RE: Response to November 12, 2021 Adequacy Review, Mineral Mountain Project, Permit M-2014-045

**Responses to Elliot August 6, 2021 Deficiency Letter
September 16, 2021
Responses to Elliot October 22, 2021 Deficiency Letter
October 26, 2021
Responses to Elliot November 12, 2021 Adequacy Letter #3
November 17, 2021**

Engineering Design for Concrete Floor in Mill Room and Chemical Storage Room and Sump Room Berm.

Install Half-Foot High Berm at Entrance to Sump Room

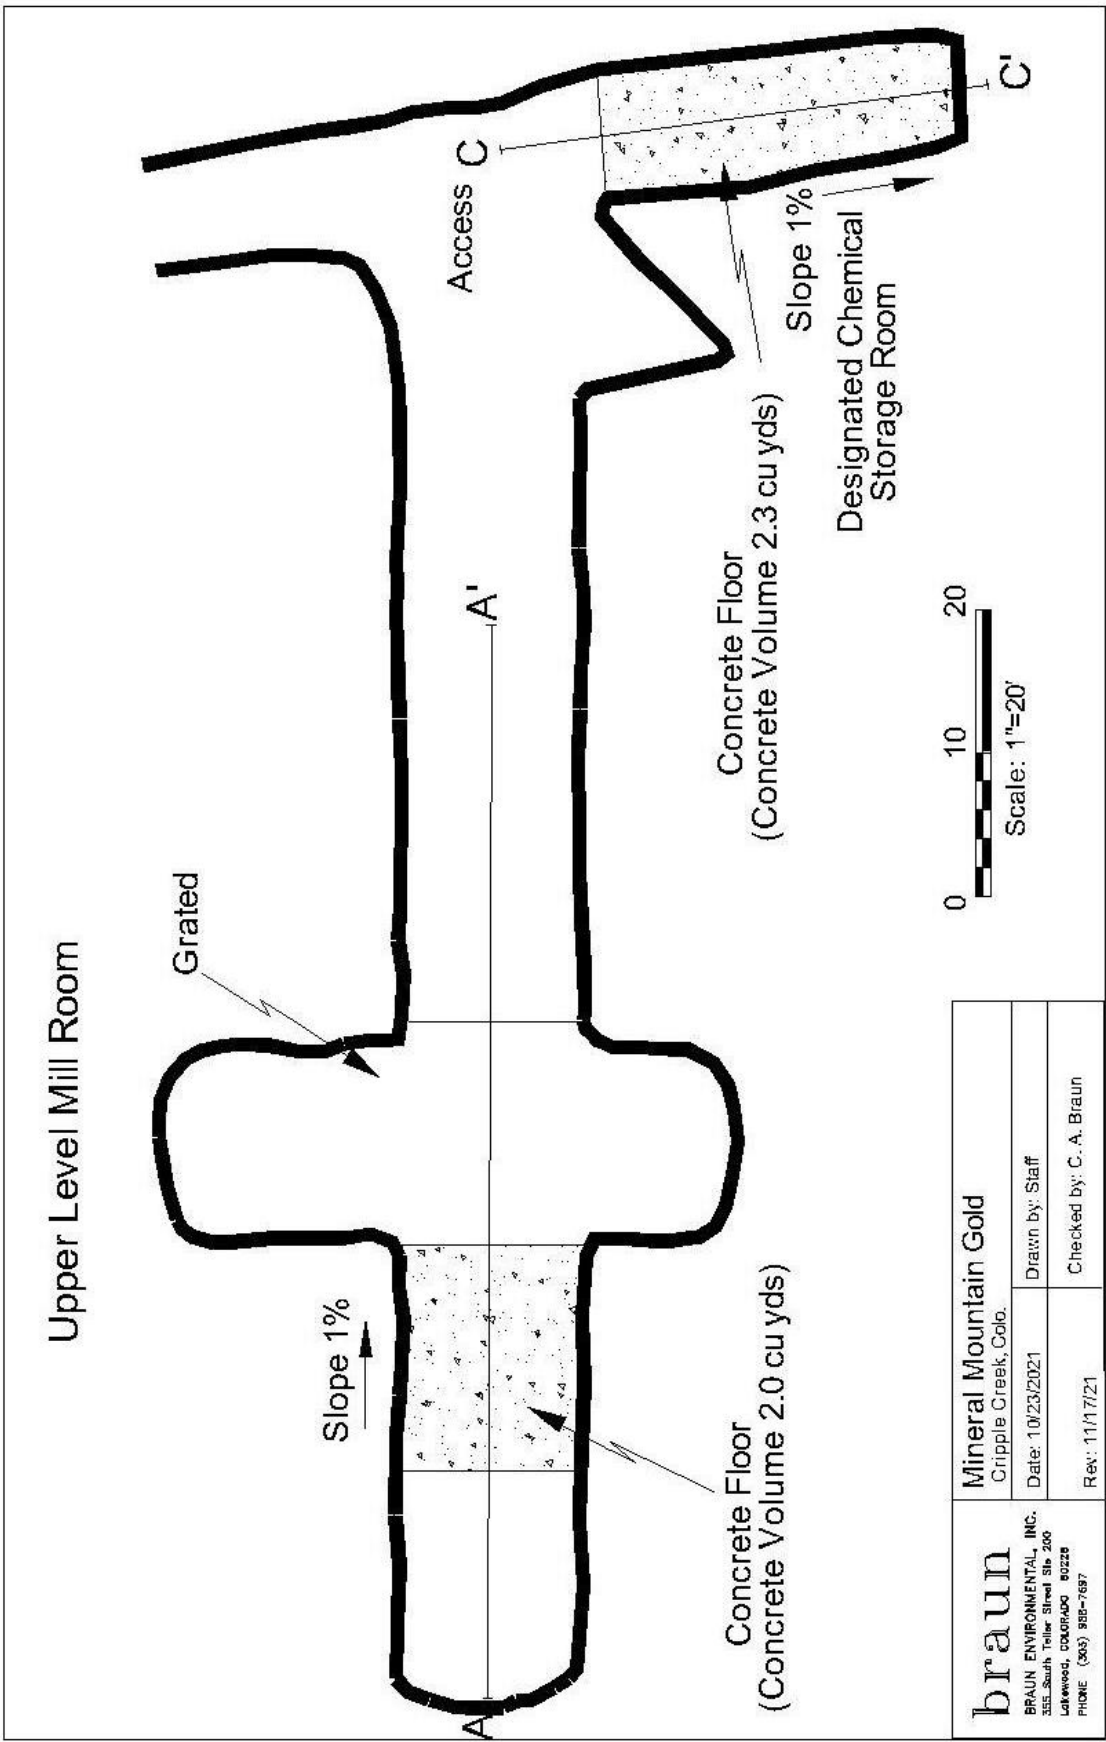
Comment 6. Please describe how the Operator will prepare the floor and key-in the proposed 0.5 foot high concrete berm at the entrance to the sump room to ensure that all fluids captured by the berm are contained directed to the sump room.

Response: The most recent response is as follows: “A 0.5 foot high berm has been added to the entrance to the sump room to ensure that all fluids entering up-gradient are captured into it. This room had 5 times the fluid holding capacity of the entire processing equipment, thus it is sufficiently large to retain any overflow of spill. Further, the operator commits at limiting it use to no more than 90 percent of its capacity, thus, making additionally sure that no overflows will occur.”

As for all properly constructed mine seals it is essential to key in the feature to cause it to stay in place and to retain its seal, and the installation is considered standard to the industry. The specific detail to this is so common that it was not included in the last response. However, the detailed installation has now been added to the Engineering Design for Concrete Floor in Mill Room and in Chemical Storage Room.

- 1 Remove mud and debris from sill in area where berm is to be installed,
- 2 The key is to be cut one foot deep, or more if necessary to reach solid rock, and cut no less than 0.5 feet into each side rib, Make certain to not to over-blast and to undercut rib that might cause danger to personnel.
- 3 Cut key in sill at angle shown in figure. TMIC
- 4 Install forms as needed on lower side and use low slump concrete (less than 4" slump) to construct.
- 5 No mechanized traffic should be allowed to travel over berm until 7 days after pour.

Processing and Storage Areas Section and Details

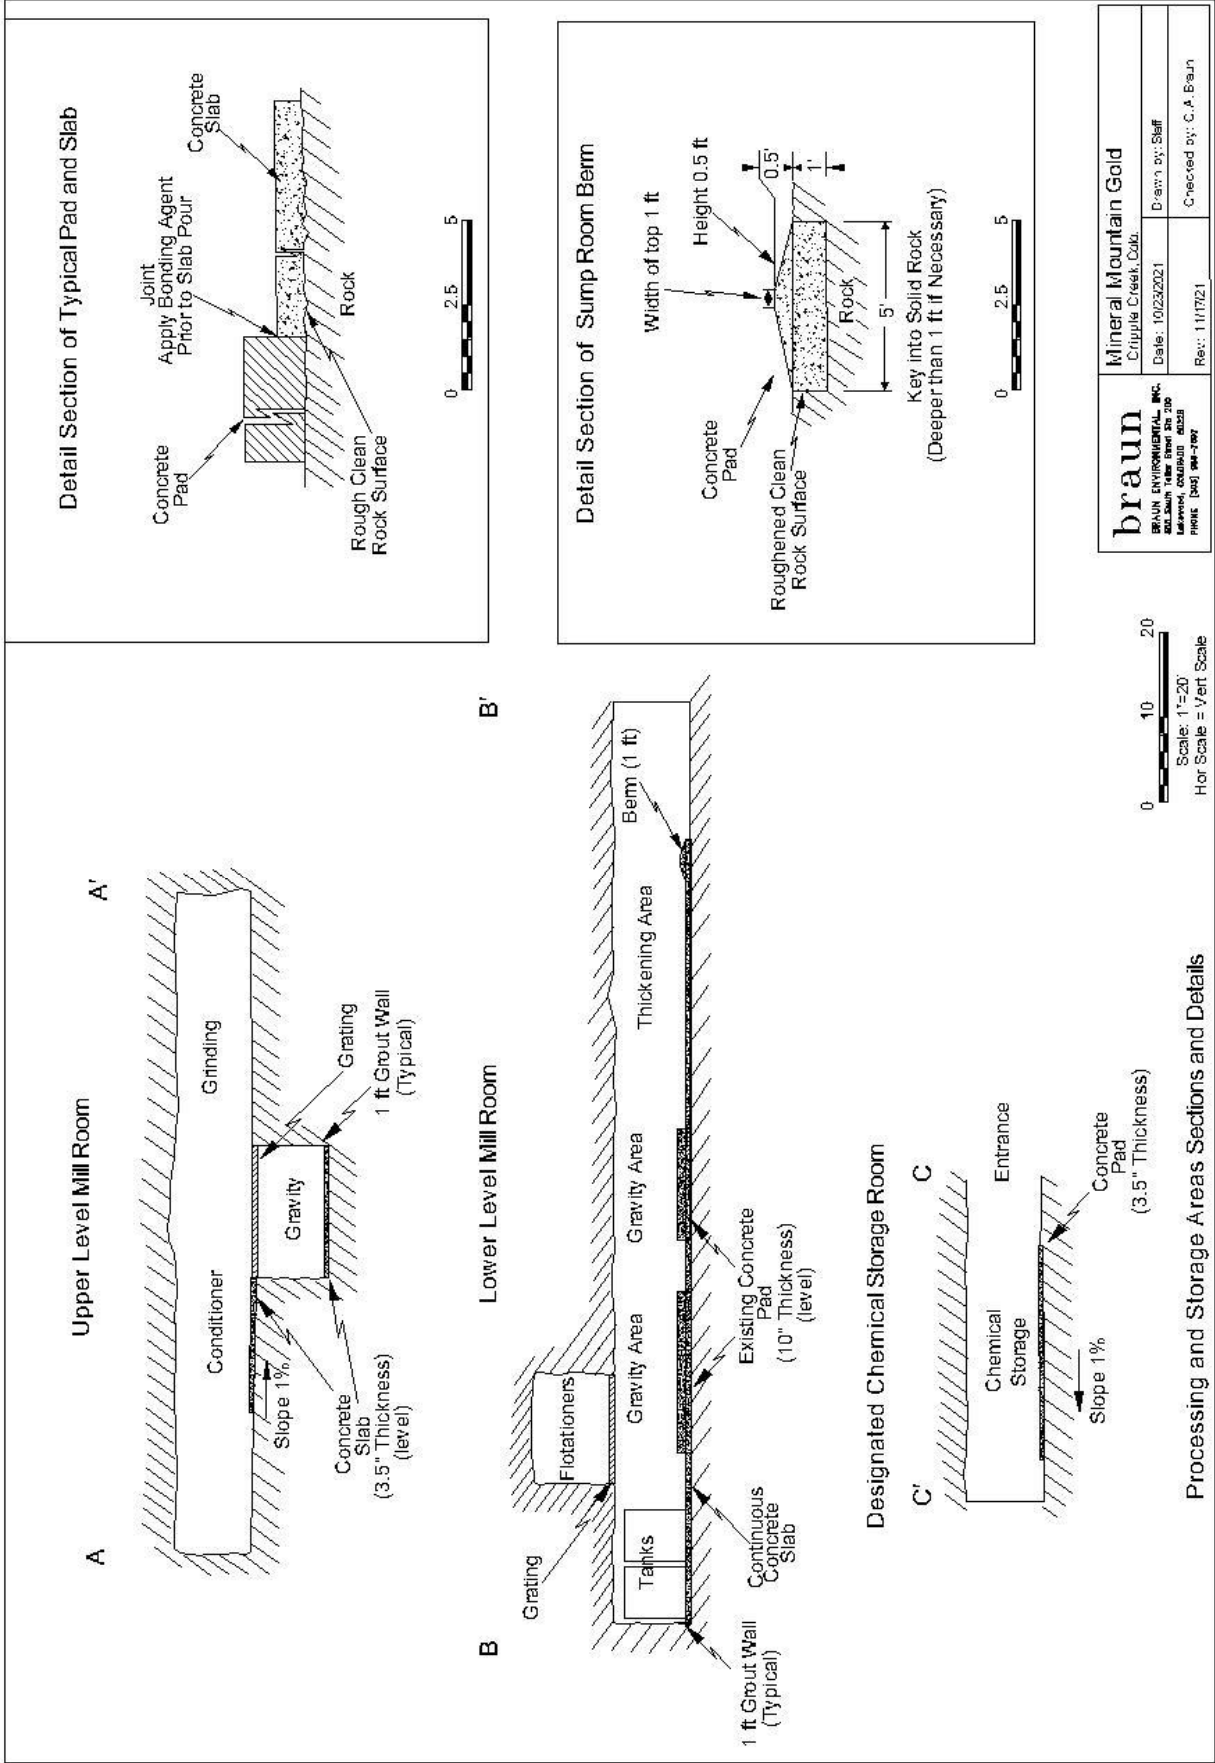
Comment 42 To accompany the *Diagram of Processing Area*, please provide cross section designs with a North-South and East-West trending depiction to show the concrete floor, sills/berms and rib coverings of the upper and lower levels of the mill including the sump room berm. Upon review of the *Diagram of Processing Area*, the

Division has discovered the Operator has relocated the proposed Designated Chemical Storage Room from the western upper mill room to a separate room located east of the grinding area. The designs, exhibits, and adequacy review response narratives do not depict or describe containment of this new proposed room. Please confirm this room will be similarly constructed as the mill room(s). Please also provide cross sectional diagrams of this room too.

Response: In the previous response the following paragraph was included to specifically address the Designated Chemical Storage Room. *“The chemical storage room and mill room is carved out of solid low permeability rock which provides a low permeability sill and low permeability ribs and backs. A low permeability concrete floor is to be poured over the low permeability rock, and that combination will easily retain the designated chemicals stored there. In addition, the operator commits to additionally use commercially available spill containers designed specifically for the size of the containers containing designated chemicals which will be stored in the room”*. The discussion was intended to be informative and relay to the reviewer that both individually and separately, that both the low permeability natural rock and the concrete floor that is to be installed are suitable for secondary containment. However, the operator was going to install individually manufactured secondary containment trays to be used as his secondary containment for the primary containers. Thus the concrete floor would essentially be tertiary containment and the rock itself would be quaternary containment.

The reviewer is reminded of the discussions that occurred between him and the operator regarding this subject, and upon receiving the reviewer’s concurrence that manufactured secondary containment was suitable for retaining spills and that the concrete floor would be only a necessity to the operator to do his housekeeping. Thus, the floor is a simply a smooth surface on which the secondary containment trays can be placed and a floor that can be swept making housekeeping easy. Per discussions between the operator and the reviewer, it was agreed that the floor within the storage room be gently back-sloped away from the entrance. However, it is cautioned that the slope not be too great so that it might cause a hazard that might increase the odds of an accidental release of the contents from the primary containers. The design drawing has been modified to reflect the updated features.
